Letter Report  
on  
Review and Evaluation  
of the  
Indian Point Probabilistic Safety Study

August 25, 1982

Sandia National Laboratories  
Albuquerque, New Mexico 87185

Reliability and Risk Assessment Branch  
Office of Nuclear Reactor Regulation  
U. S. Nuclear Regulatory Commission  
Washington, DC 20555

Figure 2.7.1-1 Effect of Including a Ramapo Fault Zone on Seismic-Caused Consequences

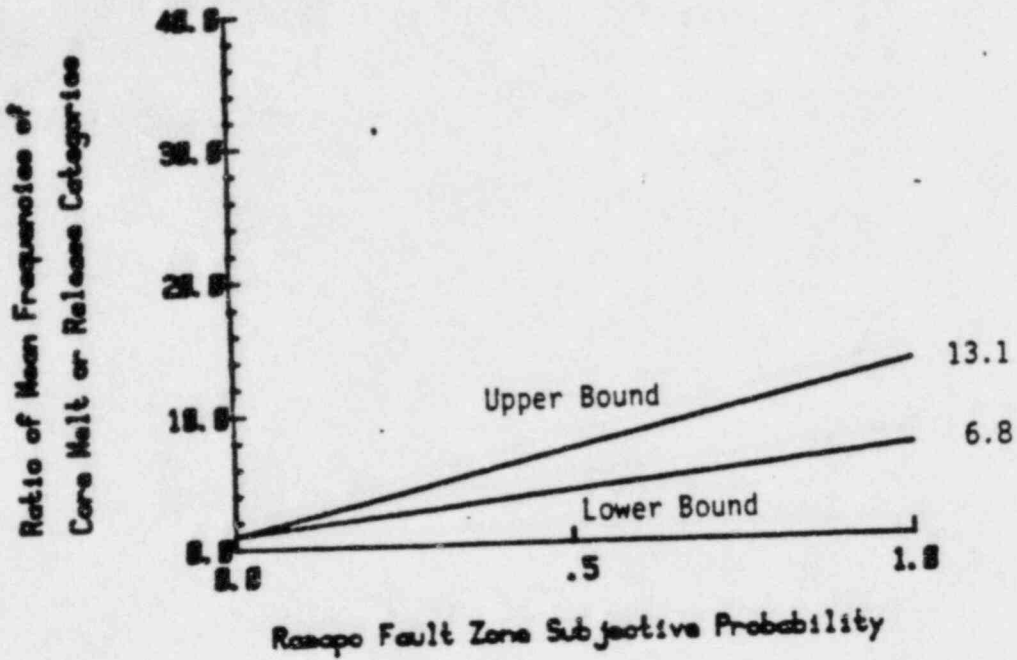
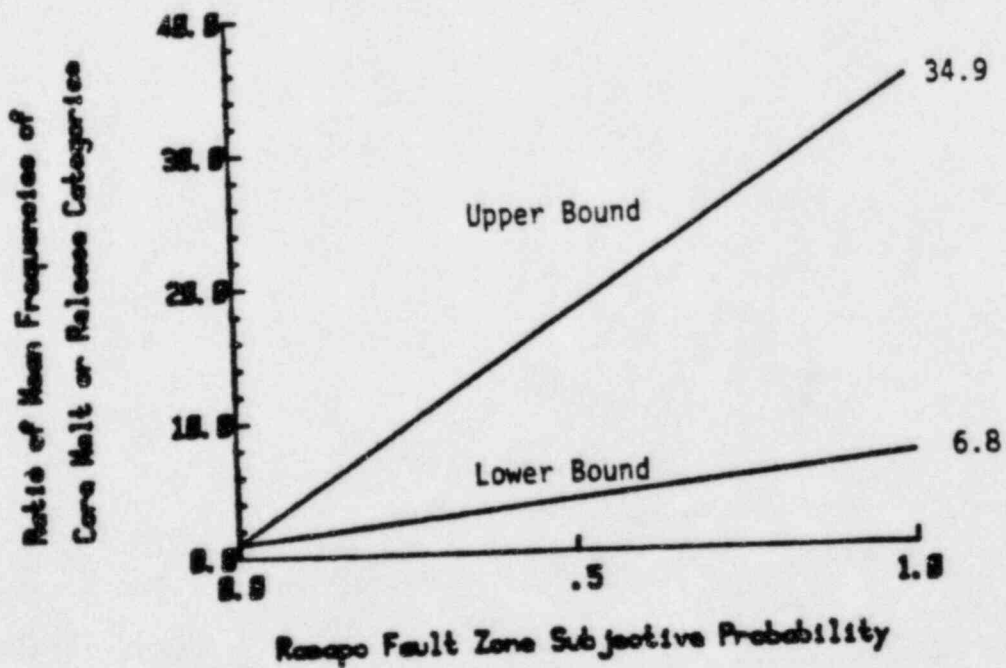
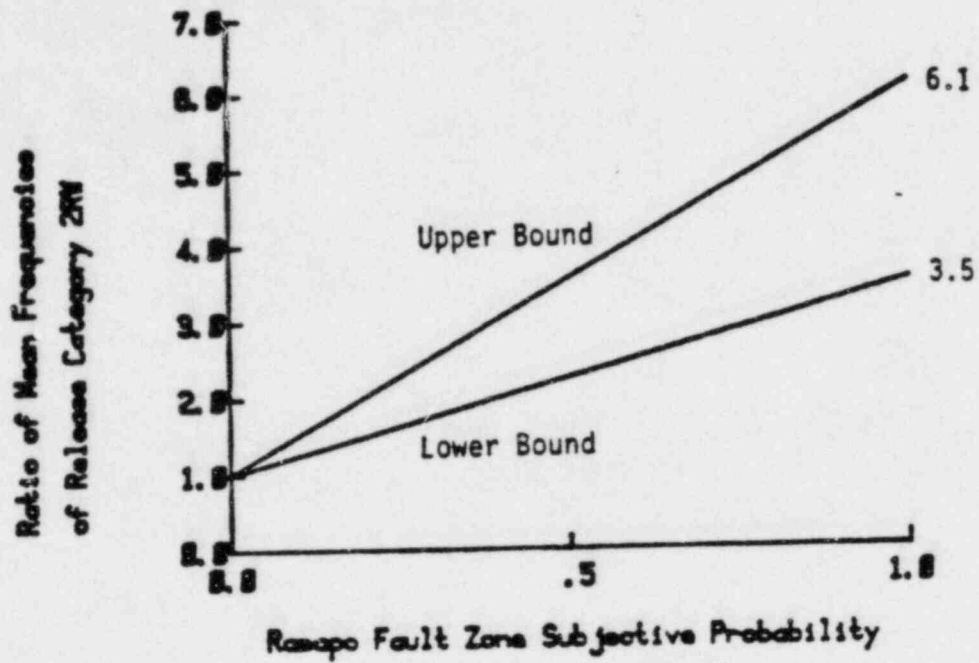
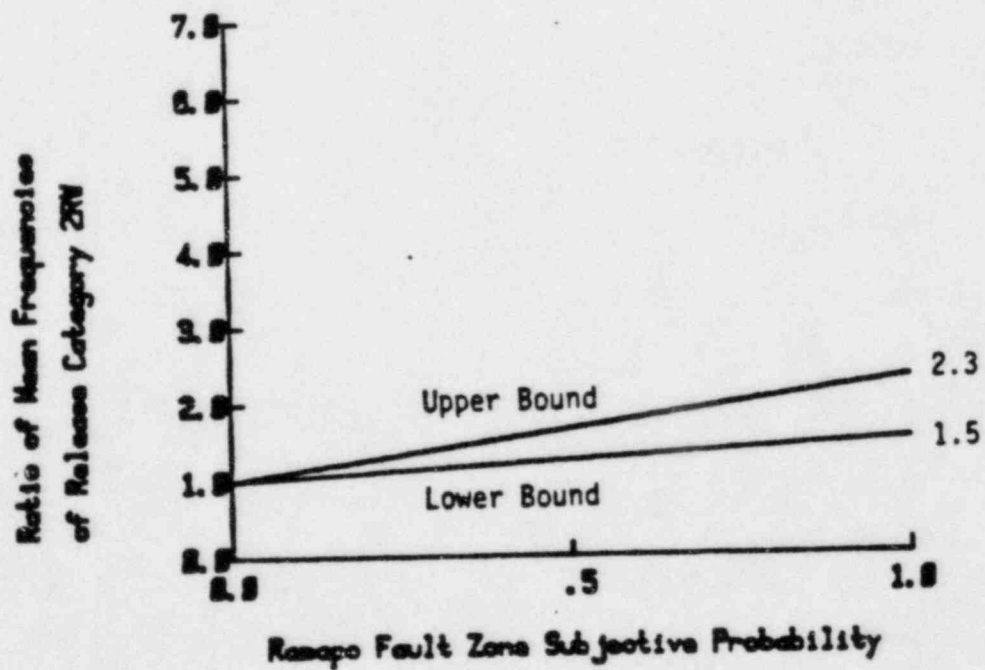
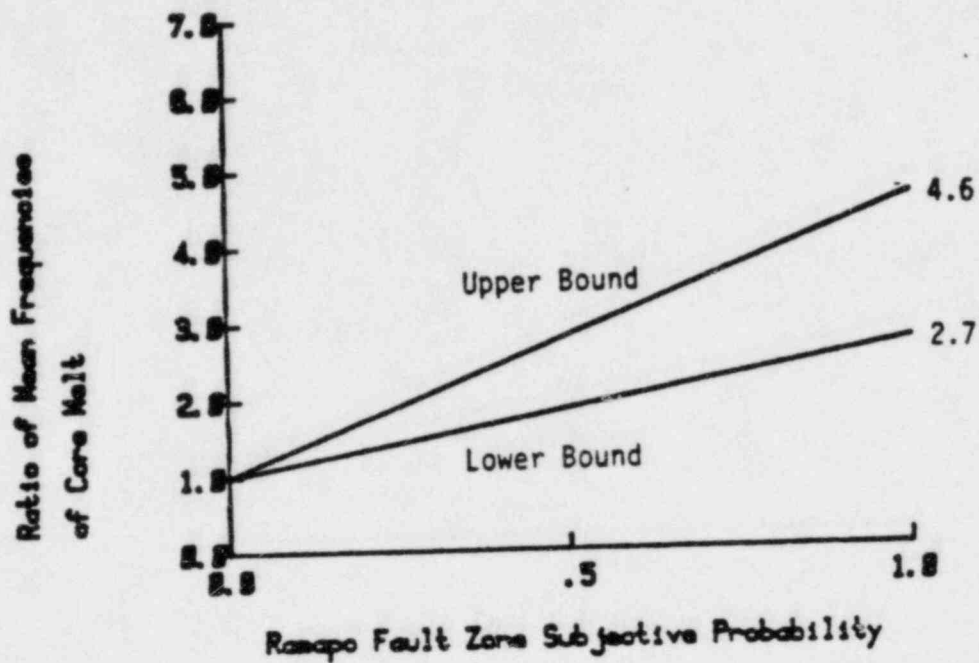
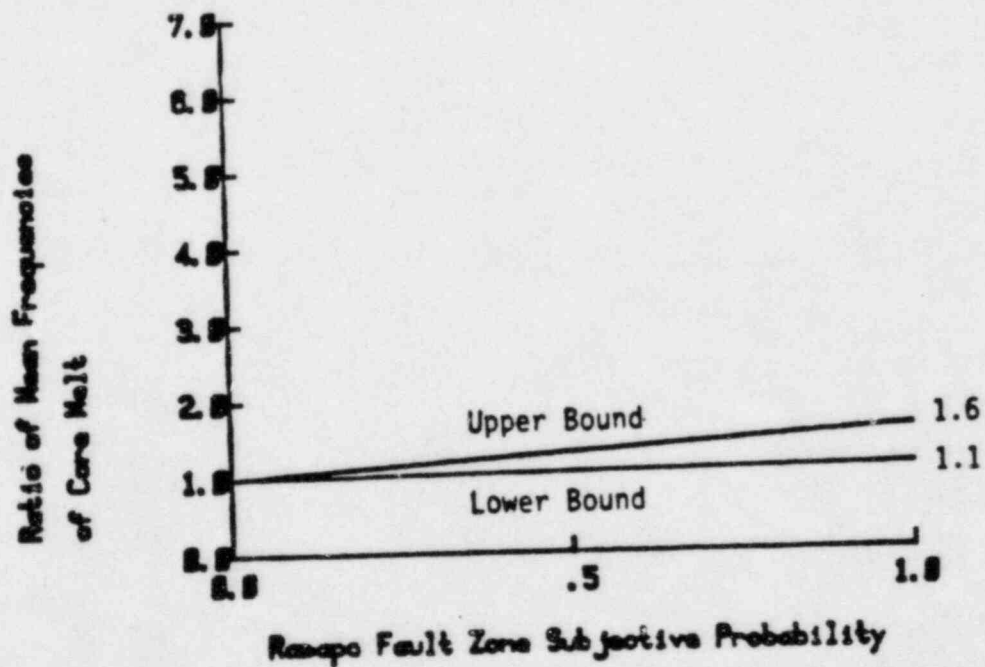
Figure 2.7.1-1 shows the effect of the Ramapo fault zone and its assumed background seismicity on the mean frequency of core melt or release categories for subjective probability values between 0 and 1. The curves were developed for release category 2RW. However, we expect the trend to be similar for other release categories and for core melt as well. Curves given for both Unit 2 and Unit 3 represent the ratio of the total seismicity-caused mean frequency (including the weighted contribution from the Ramapo source and background seismicity) to the seismically-caused mean frequency values corresponding to the IPPSS report (i.e.,  $1.4 \times 10^{-4}$  per year for Unit 2 and  $2.4 \times 10^{-6}$  per year for Unit 3). Thus the results shown in Figure 2.7.1-1 pertain only to seismically-caused consequences. The two curves shown for each plant represent lower and upper bound possible Ramapo fault zones.

Figures 2.7.1-2 and 2.7.1-3 show similar plots for total mean frequency of release category 2RW and core melt, respectively. In these plots the mean frequency values given in IPPSS report Tables 8.3-2 and 8.3-3 were used as the base values for Unit 2 and Unit 3, respectively. Thus the effect of the Ramapo fault zone on higher level consequences as function of the subjective probability for the zone can be seen.

By comparing Figures 2.7.1-1 through 2.7.1.3, it is seen that the effect of the Ramapo fault zone decreases monotonically from seismic-caused release categories, to total release category 2RW, and finally to core melt. The reason the

Figure 5 Comparison of Approximate Tornado Analysis (with Origin Area) with IPPSS Results

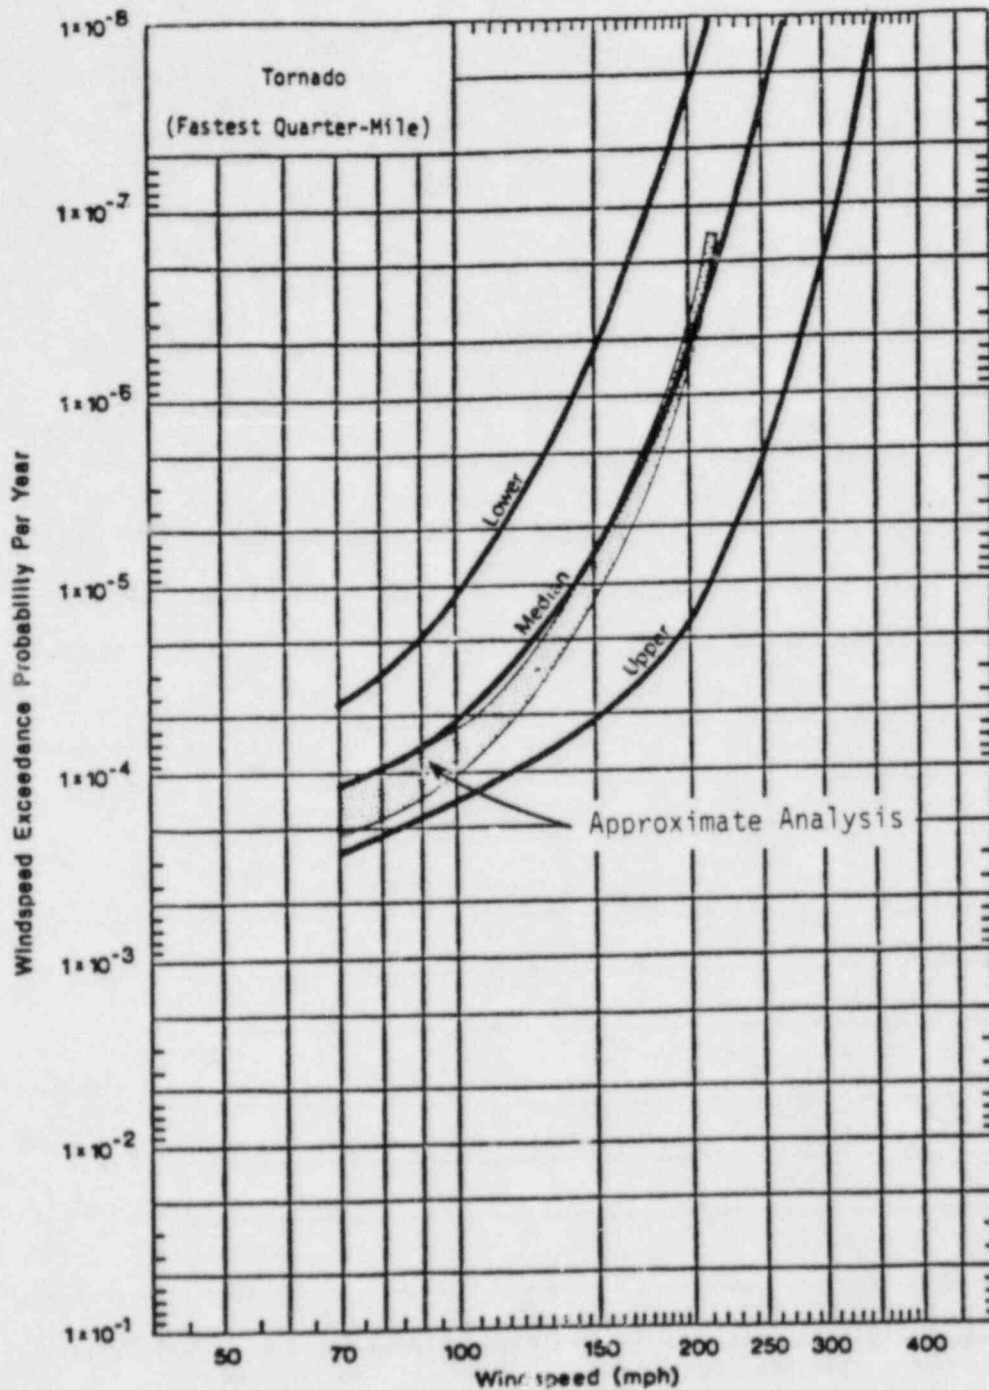
Two calculations were made to verify the distribution of wind speeds given a tornado strike. In the first check, only wind speeds corresponding to the median wind speed intervals from IPPSS report Table III-12 coupled with the distribution of F-scale values from IPPSS report Table II-11 were used. The velocity distribution was combined with the mean rate of tornado strike frequency (i.e.,  $1.1 \times 10^{-4}$ /sq mi/yr). Figure 4 shows the results superimposed on the reported curves. The approximate analysis gives conservative values. This was expected since the reduction of origin area at higher wind speed was not incorporated into the calculation. In a second analysis, the origin area was reduced using average path lengths and path widths with frequencies corresponding to F-scale values obtained from Appendix B of IPPSS

report Section 7.9.5. Figure 5 shows the results superimposed on the reported curves.

Based on an approximate analyses and our belief that the tornado hazard at the Indian Point site is lower than the area selected in the IPPSS study, we feel that the median hazard curve shown in IPPSS report Figure III-7 is conservative.

Figure 4. The effect of b-values on the seismicity curves for the Aggarwal and Sykes Ramapo fault zone.

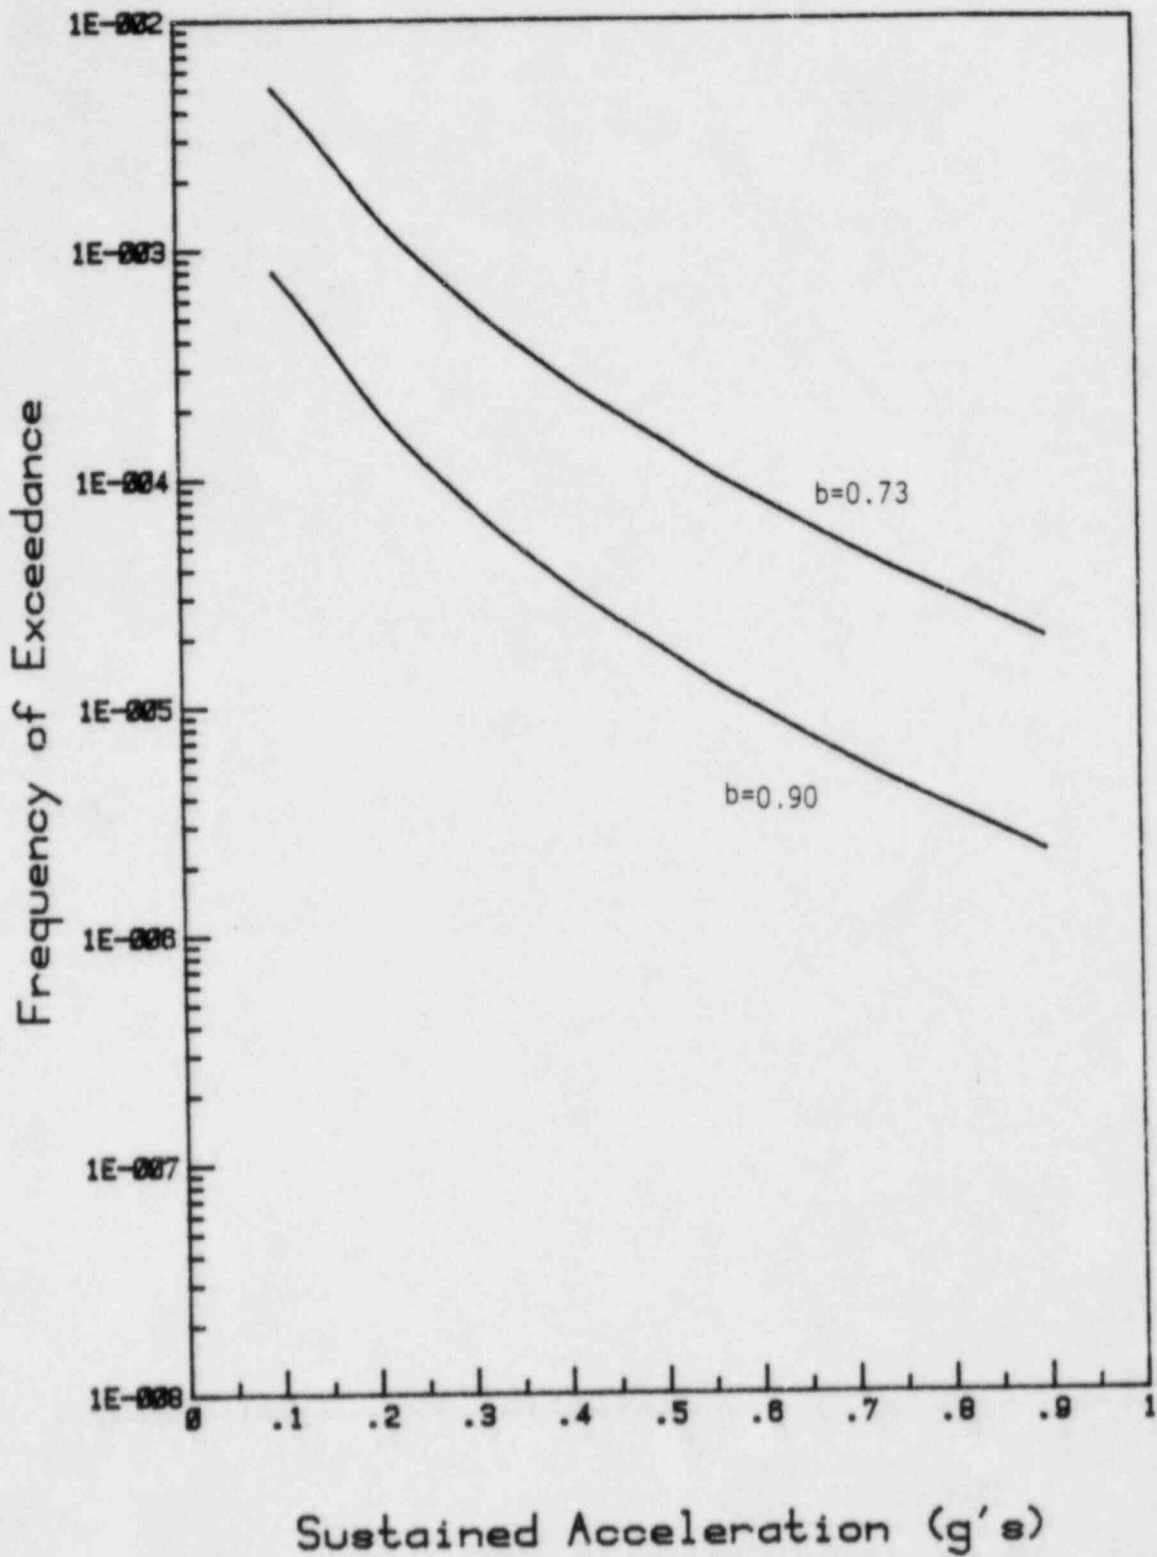
In Figure 4 we investigate the effect of varying the Richter b-value. Two cases are considered,  $b=0.73$  and  $0.90$ . The seismic activity rate is held the same, thus the effect is to considerably lower the occurrence rate of large events. As a result, the seismicity for a  $b=0.90$  is considerably less (by an order of magnitude) for the case of  $b=0.73$ .
